MEETING NOTES
Stevens Creek Hydroelectric Project (FERC No. 2535)

March 19, 2024

The purpose of the meeting was to review and discuss the 2023 Water Quality Study Report (WQ Study) for the Stevens Creek Hydroelectric Project (Project).

Results – Continuous Monitoring

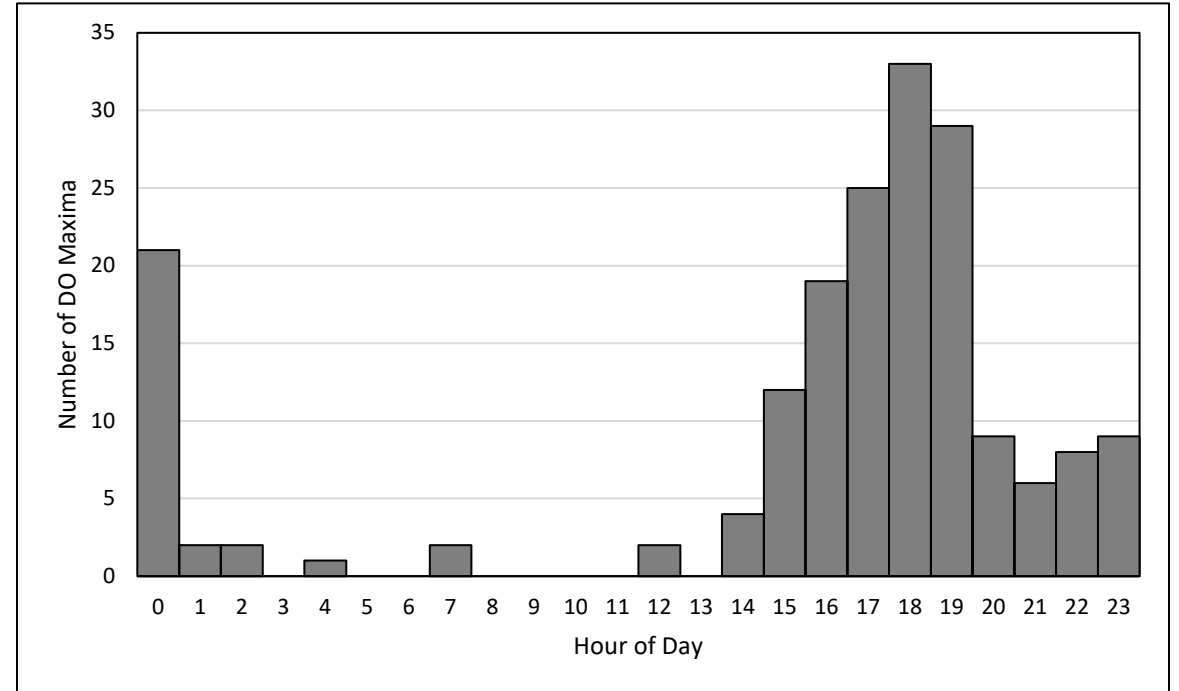
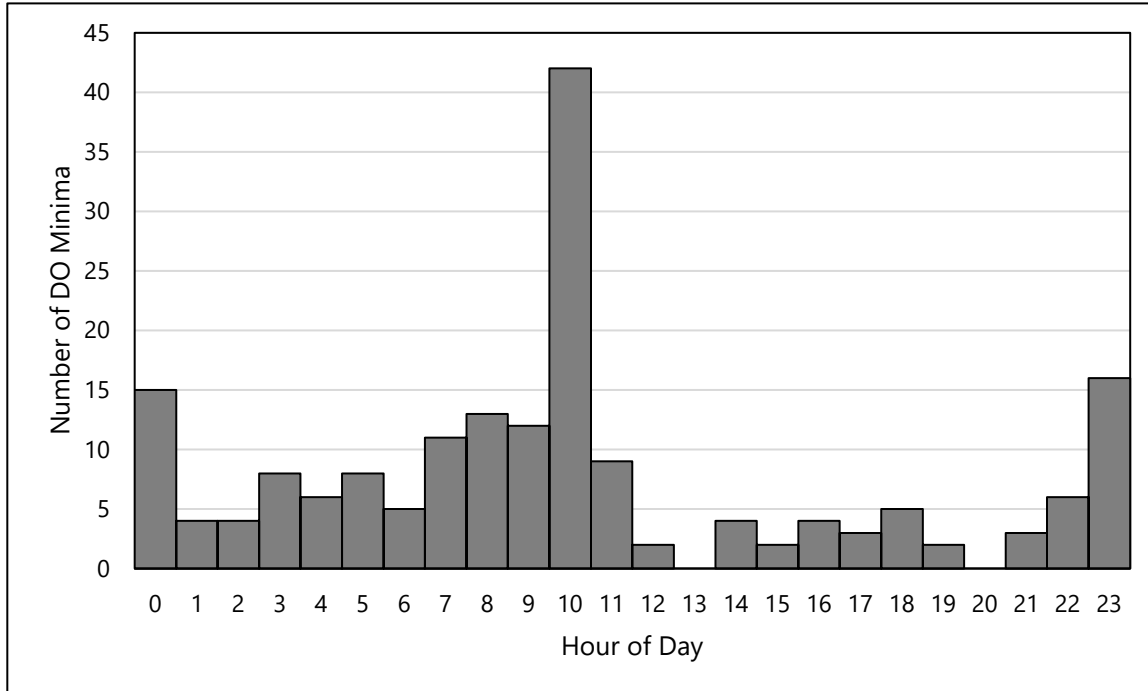
Jason reviewed graphs that depicted the time of DO minima and maxima occurrence at RM 4.5. The lowest DO occurs at approximately 10:00 AM, and the highest DO occurs in mid-to late-afternoon. Kevin, NMFS, asked if similar figures were created for the 2021 Water Quality Study Report. No, but DESC/Kleinschmidt will add a section to the 2023 report to include the information.

- Dominion/Kleinschmidt to revise the 2023 Water Quality Study Report to include the following:
 - Thurmond Dam operations in 2021 and 2023
 - Time of DO minima and maxima occurrence in 2021

Flashboards and Water Quality

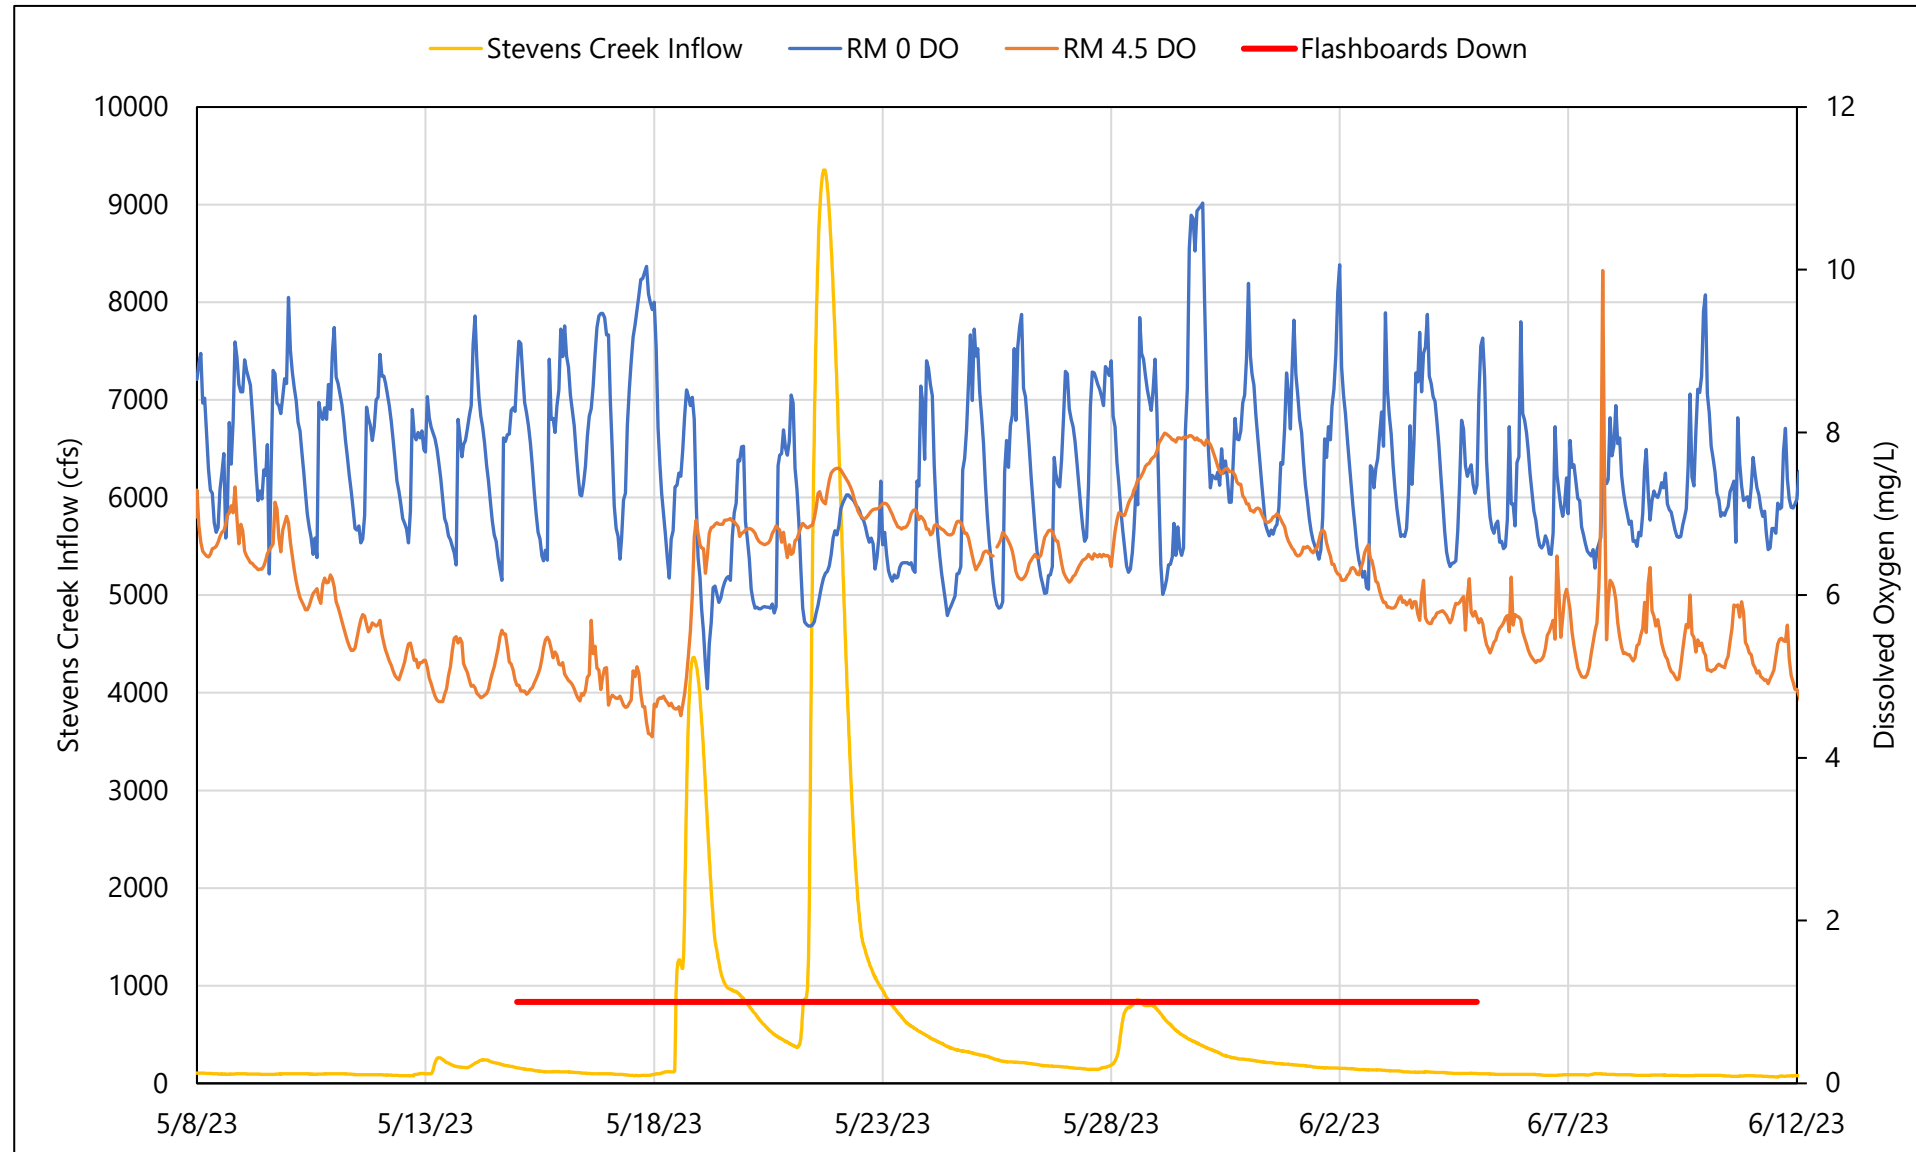
Jason reviewed a results figure regarding the Stevens Creek Dam flashboards and water quality. In summary, the 4-foot flashboards on the eastern side of the dam were tripped for a total of 59 days during the 2023 water quality study period. It has been theorized that spilling water over the South Carolina side of the Project spillway might allow low-DO water in the creek to be "flushed" downstream and improve DO in the creek. Based on visual examination of the figure, there does not appear to be an improvement in DO during the times when the flashboards were down or after they were reset. The exception was May 15 to June 5, but the increases in DO at RM 4.5 during that time period are likely due to high inflows to Stevens Creek upstream of this location. Bjorn stated that he believes it to be premature to not investigate mitigation measures further including pneumatic flashboards; the flow contributing to the water quality issues is unknown without hydraulic modeling.
